MIRA Technology Park

Comparative Review of Mitigation Proposals at the A5 / Drayton Lane Junction

A5 Drayton Lane Alternative Mitigation Review Report

Figure 1: Option 1 Scheme

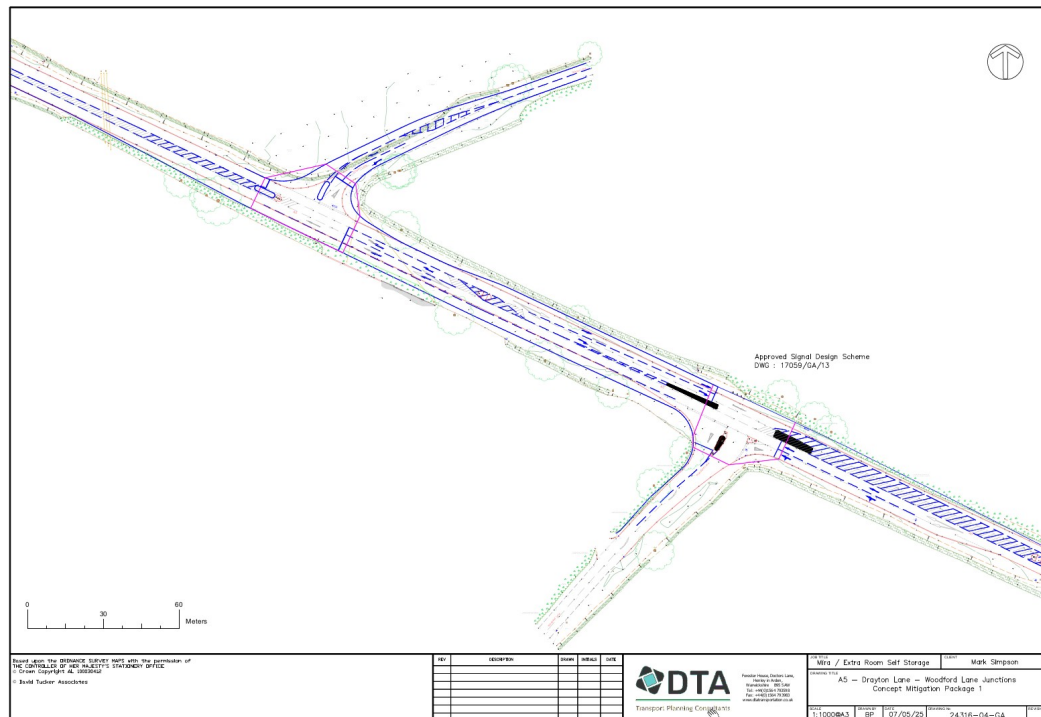
JCT Audit Notes (Page 1)														Modeller's Response				
Note Number		Comment																
1		In all scenarios, the A-C flow using the nearside lane route was locked at 210 pcus. This meant that all other A-C traffic could only use the offside lane, forcing a significant volume of traffic into the offside lane. Despite an exit merge beyond the second junction, this seemed like an unnecessary restriction in the model.												The nearside lane was locked to 210 vph (pcu) to reflect likely usage of the flare based on experience elsewhere on the A5 (Longshoot). Accept that longer funnel/merge could improve slightly.				
2		Lane J1:6/3 flare length could be increased from 5 to 7 pcus												Noted. Assumption for Drayton Lane were conservative here				
3		Storage in front of stopline and turns in intergreen, on Lane J1:6/3 could be increased from 2 to 3 pcus.												Noted. Assumption for Drayton Lane were conservative here

At Controller 1, a long 10 seconds Phase delay was applied to Phase A, from stage 1 to 3. It was not clear why this was entered. However, as this stage change does not run in the model, it will not impact the results.

The widths and radii used for saturation flow predictions generally looked reasonable, albeit the scale of the drawing was small. JCT recommend that all lanes are considered as nearside lanes, unless the lane offers an overtaking opportunity for traffic going to the same destination as traffic in the adjacent lane. This would change the nearside lane assumptions for some lanes in the model.

Figure 2: Option 2 Scheme

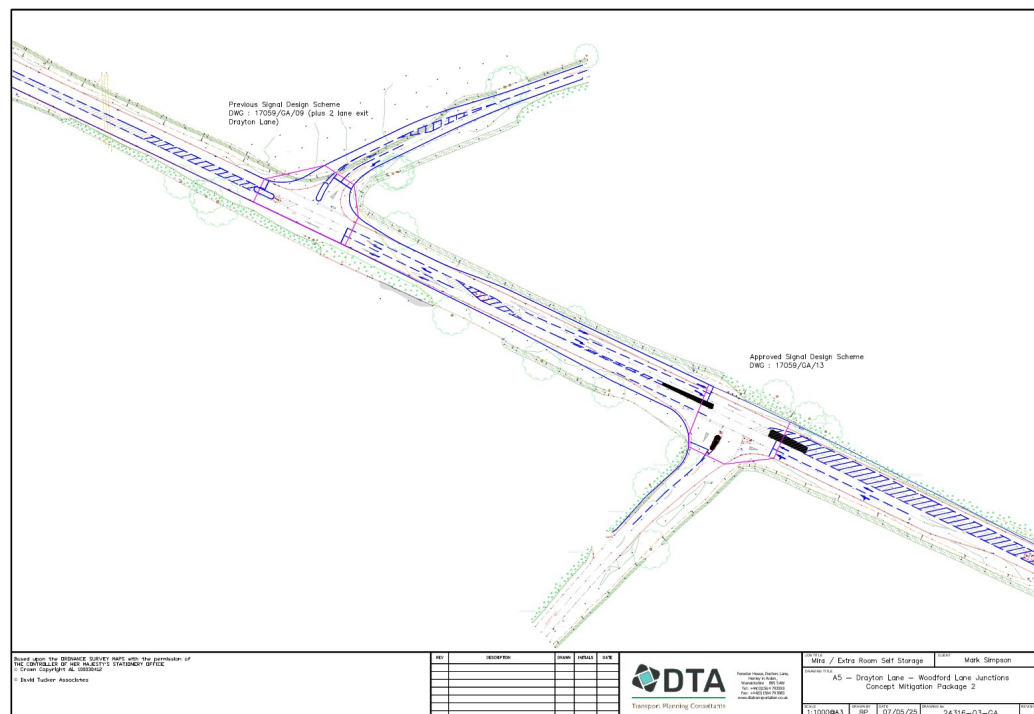
JCT Audit Notes (Page 1)												Modeller's Response						
Note Number		Comment																
1		Lane J1:6/2 flare length could be increased from 6 to 7 pcus										Noted						
2		Storage in front of stopline and turns in intergreen, on Lane J1:6/2 could be increased from 2 to 3 pcus.										Noted						
3		Lane J1:6/2 should use the lane saturation flow when opposing traffic is stopped, not the Maximum Flow										Noted. Green time is however short						
4		Controller 1 contained a filter arrow phase from J1:2/1. This may be reasonable, if there is no conflict expected with the right-turn into Drayton Ln. This will depend on right-turning traffic staying in their lane upstream of the stopline, as there is no island to the offside of the right-turn lane.										A generous corner taper was provided to ensure that there is no conflict for even the design vehicle. At detailed design a physical island could be specified or left turn filter omitted

At Controller 1, a long 10 seconds Phase delay was applied to Phase A, from stage 1 to 3. It was not clear why this was entered. However, as this stage change does not run in the model, it will not impact the results.

The widths and radii used for saturation flow predictions generally looked reasonable, albeit the scale of the drawing was small. JCT recommend that all lanes are considered as nearside lanes, unless the lane offers an overtaking opportunity for traffic going to the same destination as traffic in the adjacent lane. This would change the nearside lane assumptions for some lanes in the model.

SCALE	DRAWN BY	DATE	DRAWING No	REVISION
1/500@A3	BP	02-10-25	24316-05

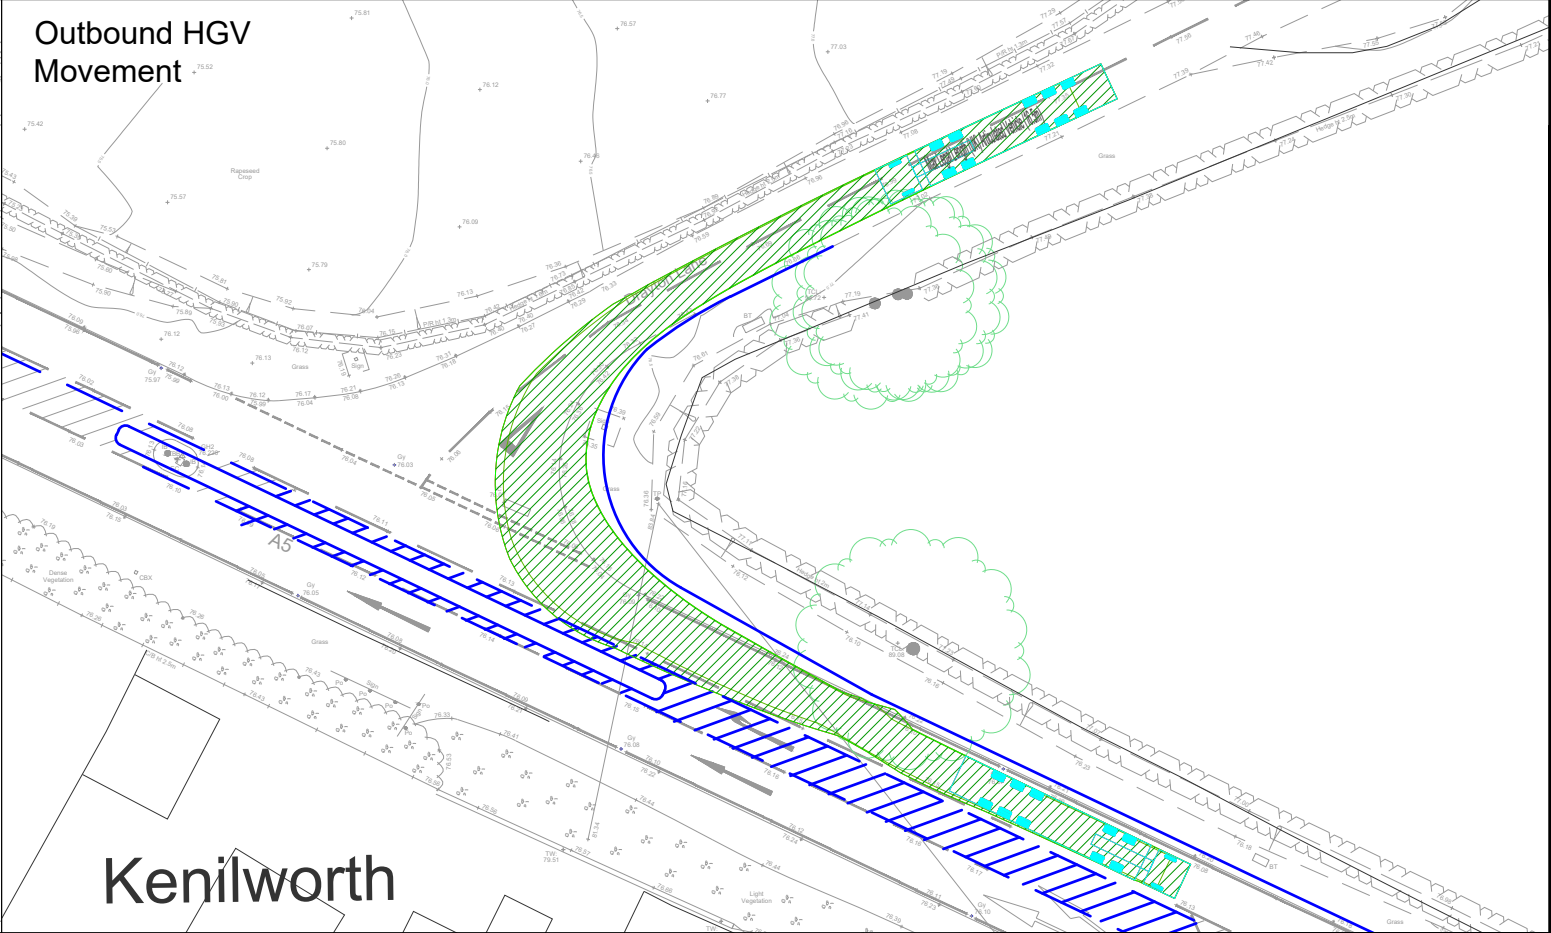
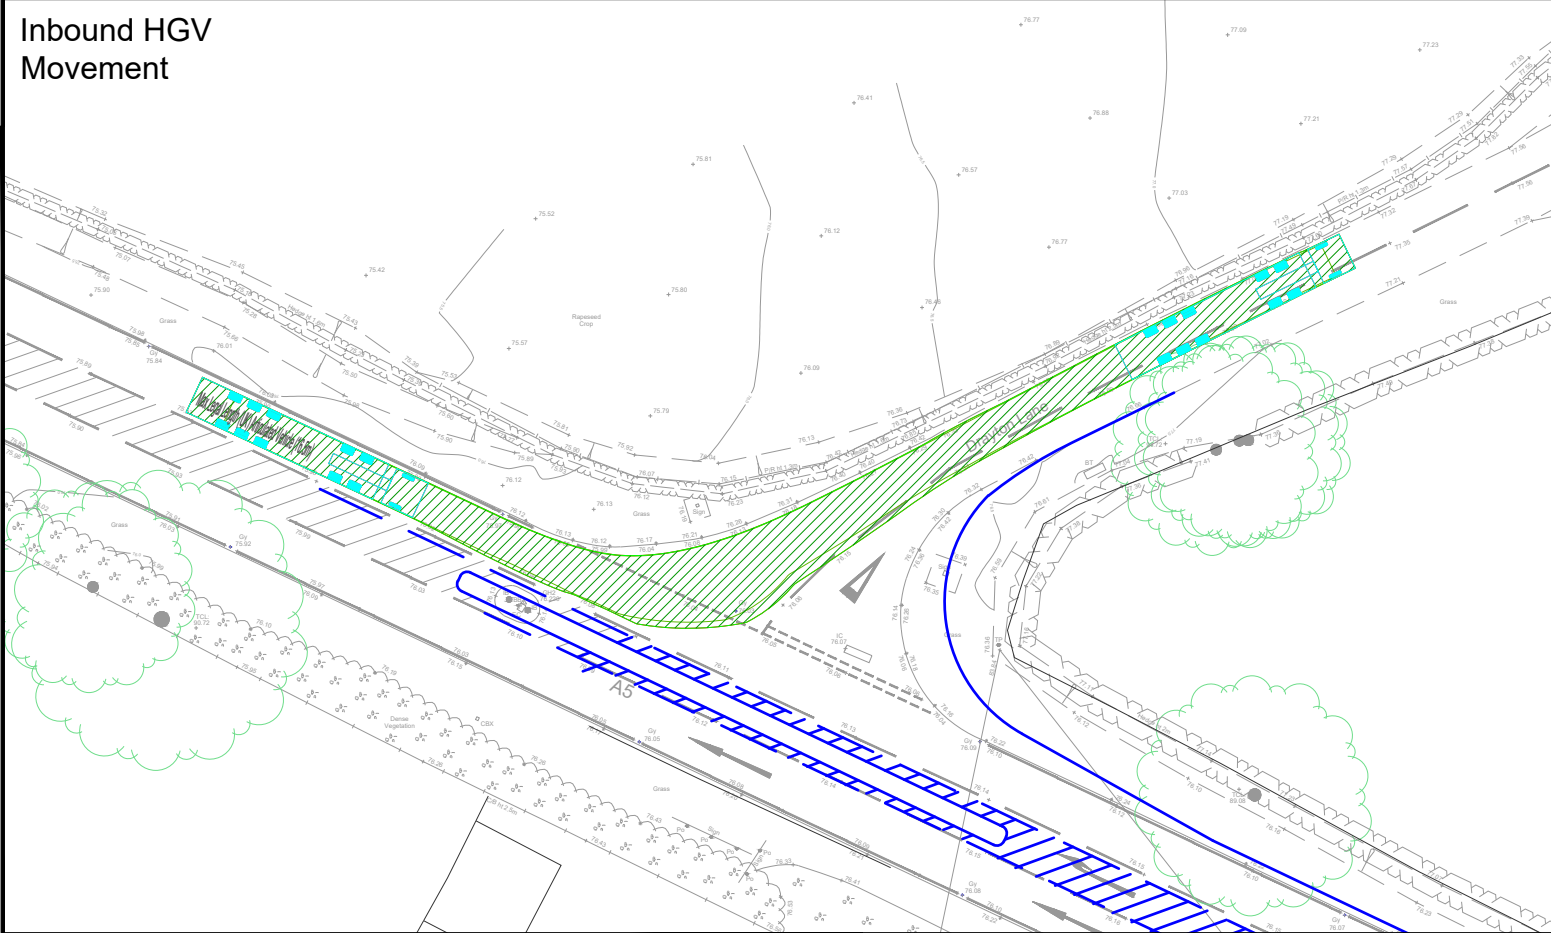
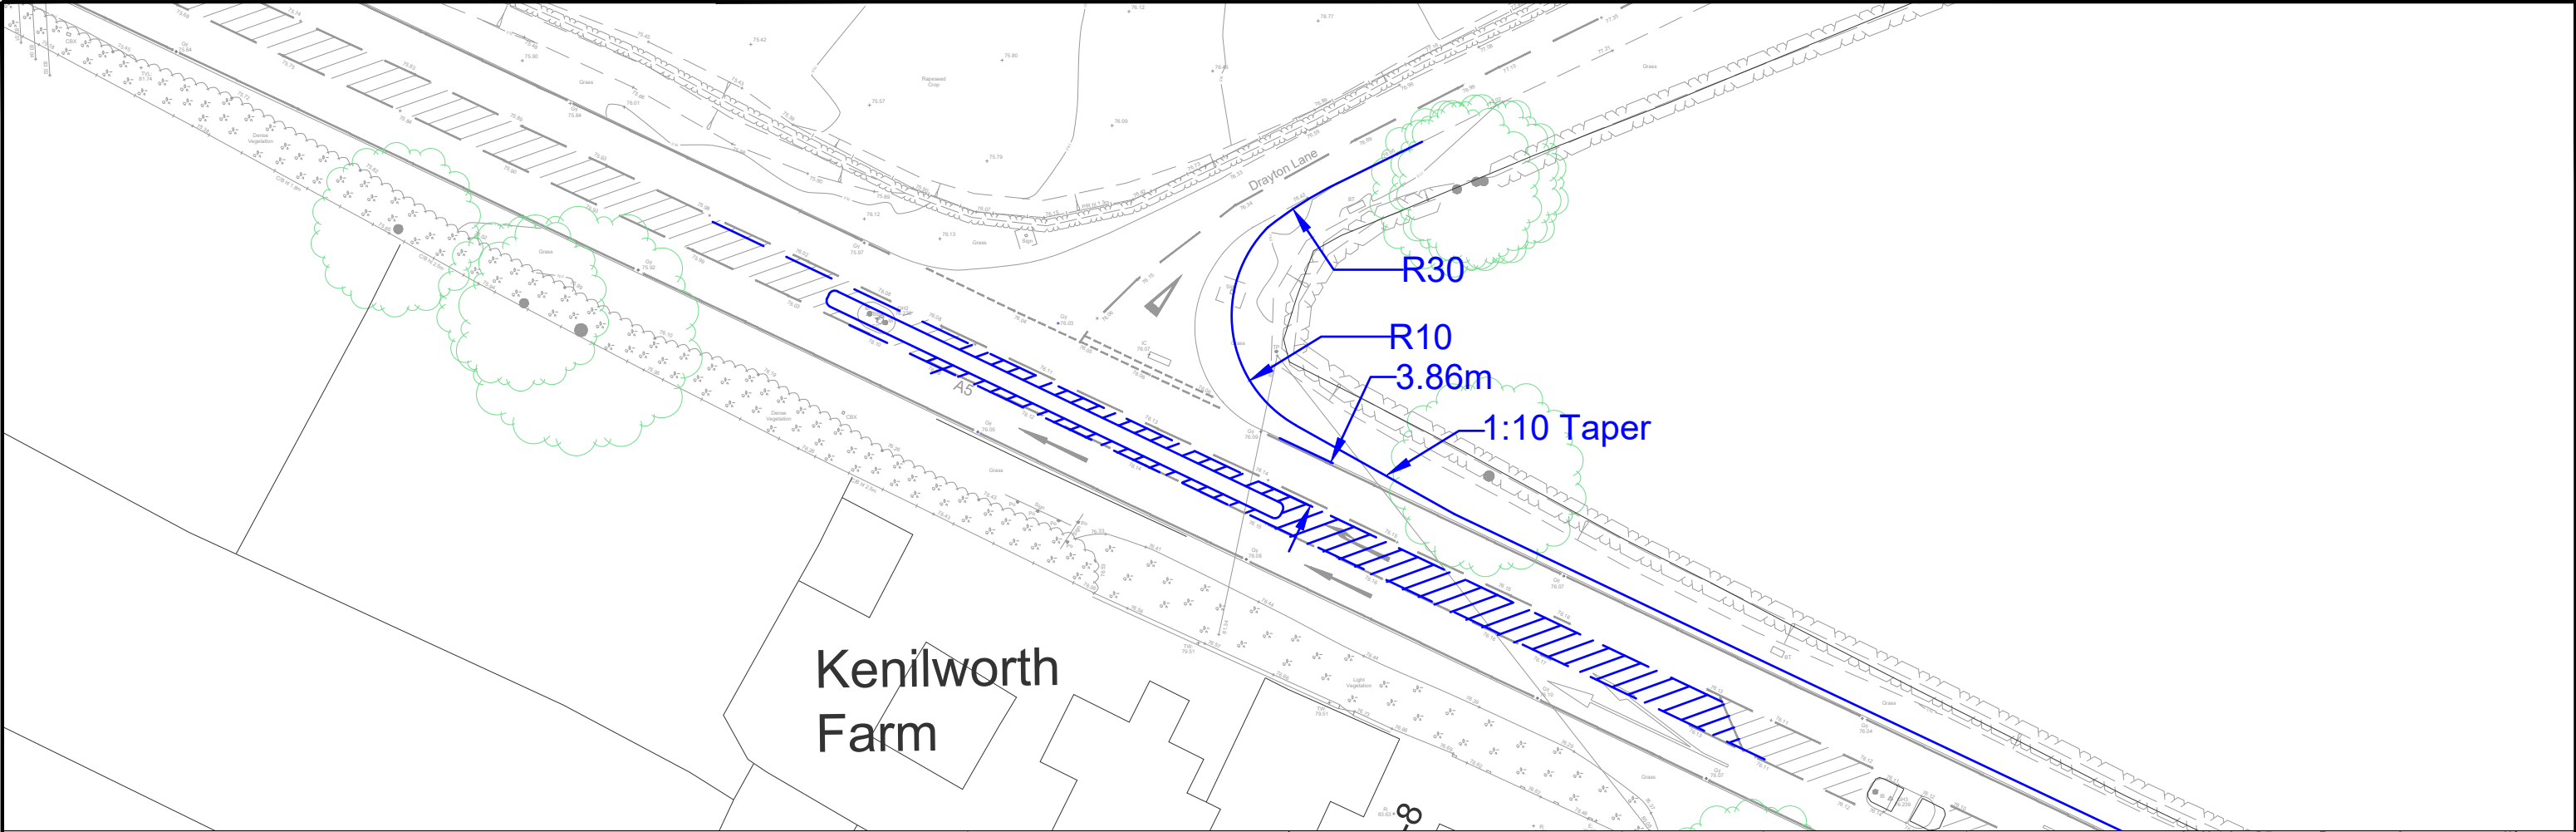
3. This issue has been assessed in more detail using the topographical survey undertaken on the junction and the tracking is shown on **DTA Drawing 24316-05**. It is clear that both movements will result in over-running of the centre line markings on Drayton Lane and therefore the concerns raised by the RSA are both clearly a significant issue.

JOB TITLE Mira / Extra Room Self Storage			CLIENT Mark Simpson	
DRAWING TITLE A5 – Drayton Lane – Woodford Lane Junctions Concept Mitigation Package 1 Vehicle Tracking				
SCALE 1:1000@A3	DRAWN BY BP	DATE 07/05/25	DRAWING No 24316-04-TK	REVISION

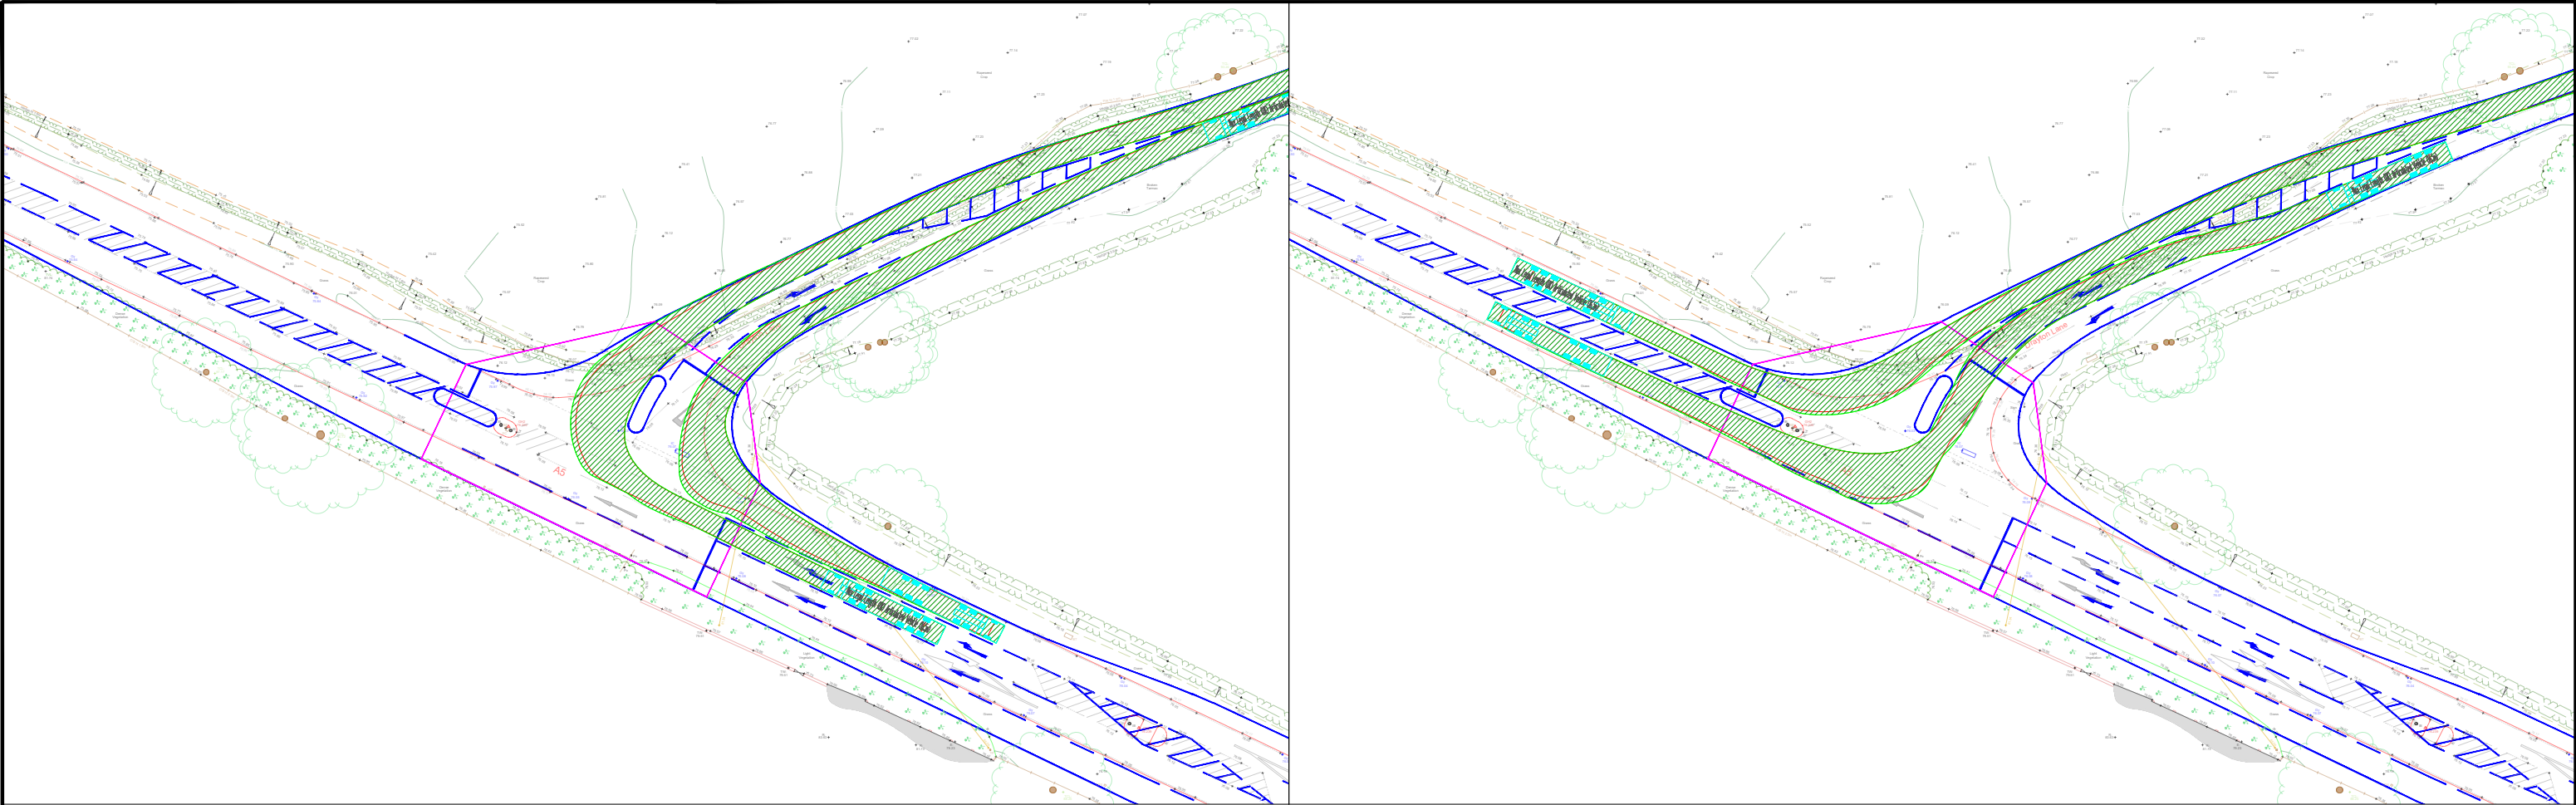
4. This issue does not arise with the proposed alternative arrangement as shown on **DTA Drawings 24316-04-TK** and **24316-03- TK**.
5. Although Drayton Lane is subject to a 7.5t weight restriction it is subject to exemptions for access and loading and therefore does carry HGV traffic, principally from the operations at Drayton Grange Farm and Extra Room Self Storage. ATC surveys undertaken at that site in February 2025 (**Appendix B**) confirm movements of HGVS to be around 16-20 movements per day. **Appendix C** shows examples of these vehicles using both the Extra Room Self Storage and the Farm.
